Replacement Requirement for Pressure Sensors for Refrigerant Circuit - Mixed Installation Not Permitted (70/24)

Vehicle Type: **Cayenne E-Hybrid (9YA/9YB)/ Cayenne S E-Hybrid (9YA/9YB)**

Concerns: **Refrigerant circuit pressure sensors**

Pressure sensor part identifier

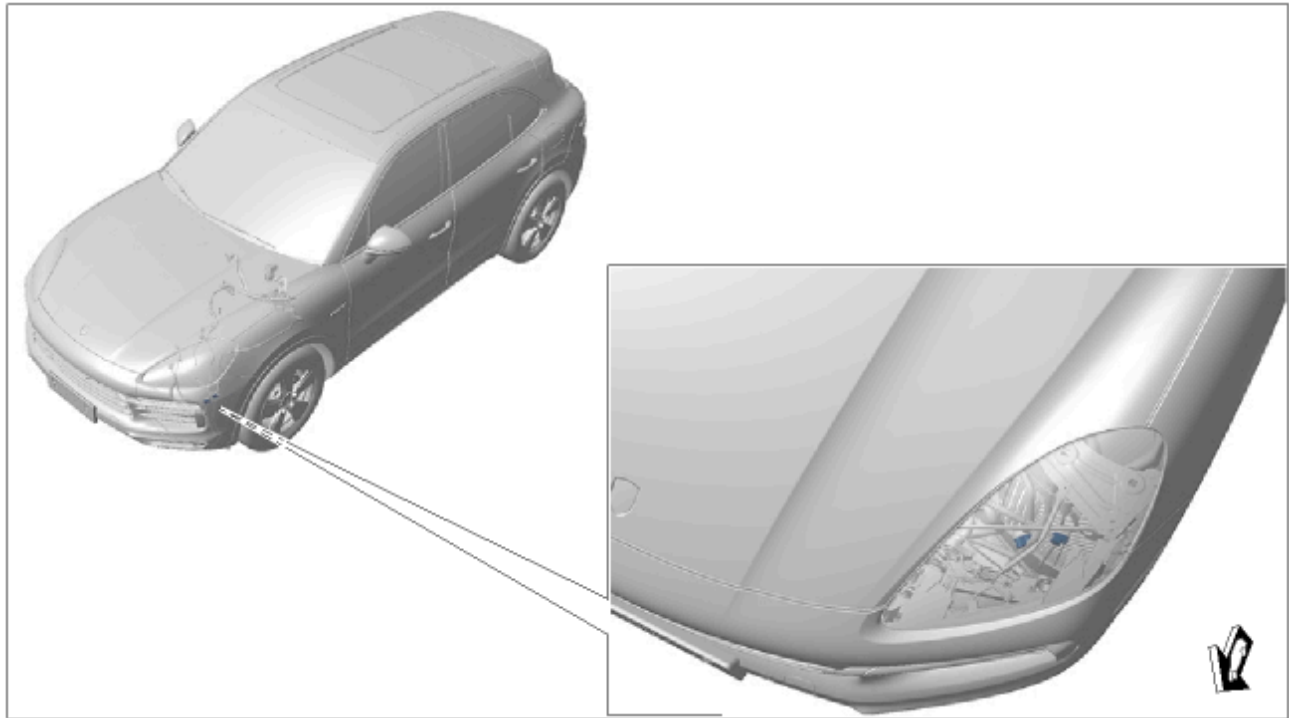
Cause: **Due to the discontinuation of an electronic component within the pressure sensor, the pressure sensors for the refrigerant circuit have been switched to a changed component status.**
 The changed component status can be identified by a changed part number.
 Pressure sensors that correspond to the changed component status are not compatible with the previous pressure sensors.
 If a pressure sensor is required for replacement, it must therefore be ensured that both pressure sensors in the refrigerant circuit correspond to the changed component status (identical part number). If this is not the case, the respective other pressure sensor must also be replaced as a one-off. Mixed installation of pressure sensors with different component status (mixed installation) is not technically permissible and leads to faults in the refrigerant circuit and in the air conditioning.

Part No.	Corresponds to the following part identifier on the component	Designation
PAB959603	4M0959603E	⇒ Pressure sensor for air-conditioning system (previous status, no longer available)
or		
PAB959603B	4M0959603J	⇒ Pressure sensor for air conditioning system (changed status)

Action: If a pressure sensor must be replaced, ensure that both pressure sensors in the refrigerant circuit correspond to the changed component status with the part identifier 4M0959603J.

If this is not the case, **both** pressure sensors must be replaced.
